AIR - HP COMPRESSOR STAGE-7 BLEED VALVES - INTRODUCTION OF CHEVRON SEALS - CATEGORY
CODE 4 - MOD.ENG-75-0053

SB Number 75-30 (Revision 1)

Introduction of HP7 Bleed Valve AC69924 Mod 2 with Chevron Seals in lieu and by conversion of AC69859 & AC69924 Mod 1

Figure 1 Pre and Post Mod Configuration of HP7 Bleed Valve

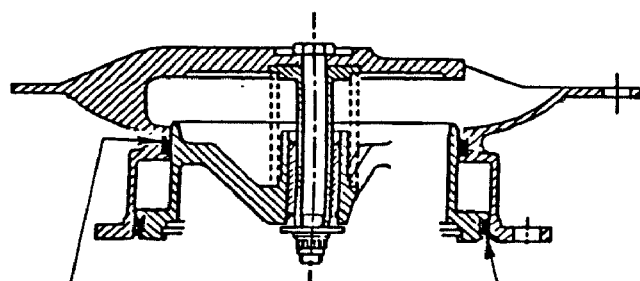
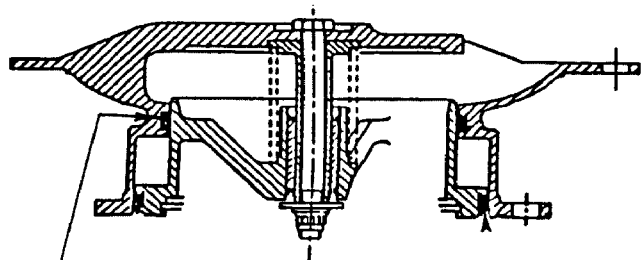
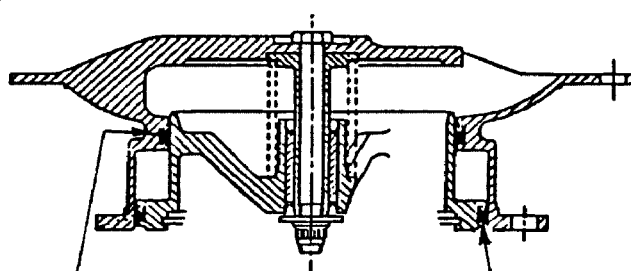
Replacement of Piston Triple Seal Assembly DAS2485-1256 by a new 'Chevron' Seal Assembly ACO47190 Issue 2.

Replacement of Body Triple Seal Assembly DAS2505-1225 by a new 'Chevron' Seal Assembly ACO47189 Issue 1.

Replacement of Piston 'Chevron' Seal Assembly ACO47190 Issue 1 by a new 'Chevron' Seal Assembly ACO47190 Issue 2.

(2) Refer to figure 1 for pre and post mod configuration of the Bleed Valve

HP7 Bleed Valve AC69859 Mod 1

Carbon Body Seal
DAS 2505-1225

Carbon Piston Seal
DAS2485-1256

HP7 Bleed Valve AC69924 Mod 1

Chevron Body Seal
ACO47189 Issue 1

Chevron Piston Seal
ACO47190 Issue 1

Pre Mod E592 Issue 2

HP7 Bleed Valve AC69924 Mod 2

Chevron Body Seal
ACO47189 Issue 1

Chevron Piston Seal
ACO47190 Issue 2

Post Mod E592 Issue 2

Figure 2 Exploded View of Bleed Valve P/N AC69924 Mod 2
(* Denotes Items contained in Mod Kit PN ACO47197 Issue 2)

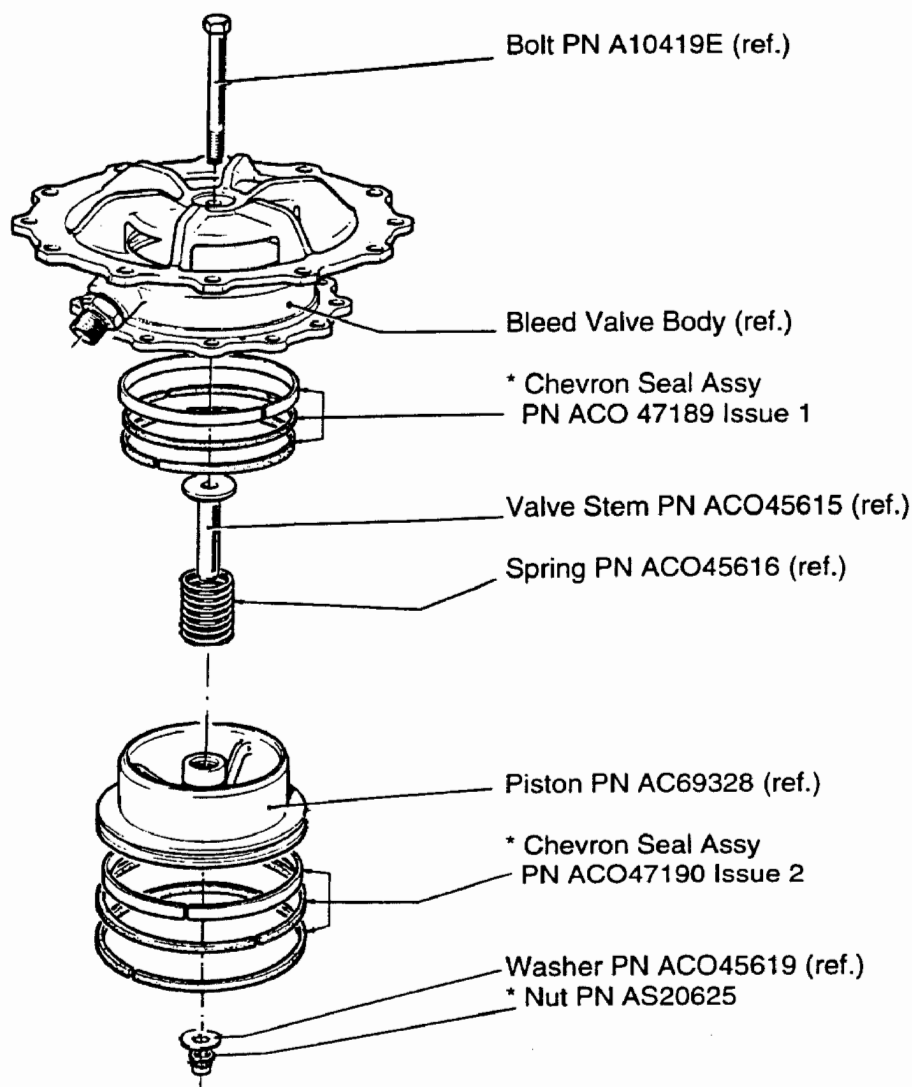
B Disassembly Instructions. (Refer to Figure 2).

(3a) Remove the PN DAS2485-1256 Carbon Triple Seal Assembly from the Piston. Discard the PN DAS2485-1256 Carbon Triple Seal Assembly

(4a) Remove the PN DAS2505-1225 Carbon Triple Seal Assembly from the Bleed Valve Body. Discard the PN DAS2505-1225 Carbon Triple Seal Assembly.

(3b) Remove the PN ACO47190 Issue 1 Chevron Seal Assembly from the Piston. Discard the PN ACO47190 Issue 1 Chevron Seal Assembly

- (1) Install a new PN ACO47189 Issue 1 Chevron design carbon / nimonic Triple Seal Assembly in the Bleed Valve Body.
Make sure the ring gaps are equispaced around the circumference.

- (4) Install the PN ACO45616 Spring on the Valve Stem.
- (5) Install a new PN ACO47190 Issue 2 Chevron design carbon / nimonic Triple Seal Assembly on the PN AC69328 Piston.
Make sure the ring gaps are equispaced around the circumference

- (10) Using the Acratork Model A, Britool AB312 and AB437 Tools torque tighten the PN AS20625 Nut to 8,5/9,0 Nm (75/80 lbf in.) plus the torque required to overcome the lock properties of the Nut.
